STANDARD PRACTICES - ENGINE - INFORMATION - ENGINE - MAIN GEARBOX ASSEMBLY
IDENTIFICATION MARKINGS ON OIL SCAVENGE PUMP - CATEGORY CODE 7 - MOD.ENG-70-0603

V2500-ENG-70-0603

International Aero Engines
INFORMATION BULLETIN

Oil scavenge pump assembly
Fig.1

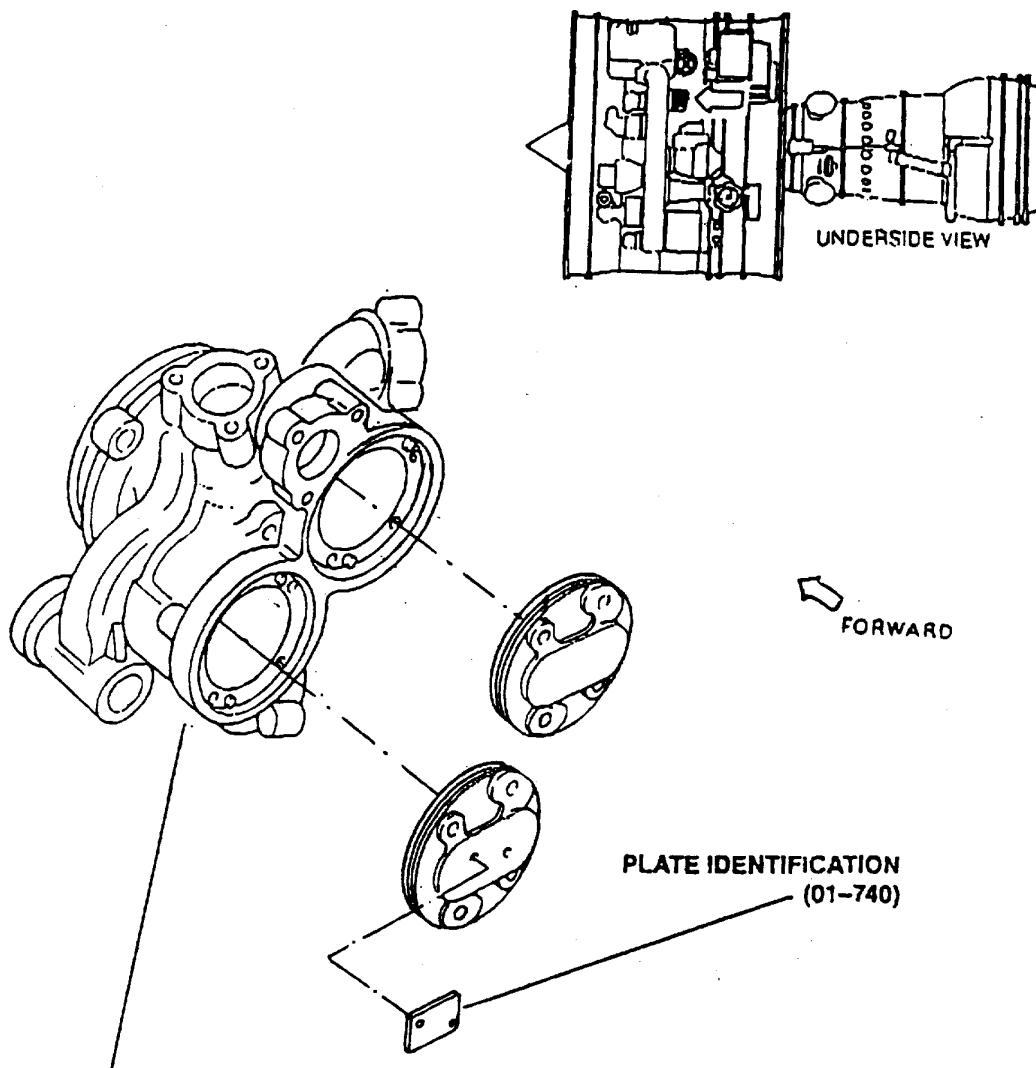
To announce the availability of a revised Oil Scavenge Pump Assembly similar to the existing item except for:

- (1) Deletion of the Identification Marking of the inlet ports.
- (2) Installation of the Data Plate on the lower cover.

- (FOR A1 MODEL) OLD P/N 4A7117-B
NEW P/N 4A7117-C .
- (FOR A5 MODEL) OLD P/N 4A7118-B
NEW P/N 4A7118-C
- (FOR D5 MODEL) OLD P/N 4A7119-A
NEW P/N 4A7119-B
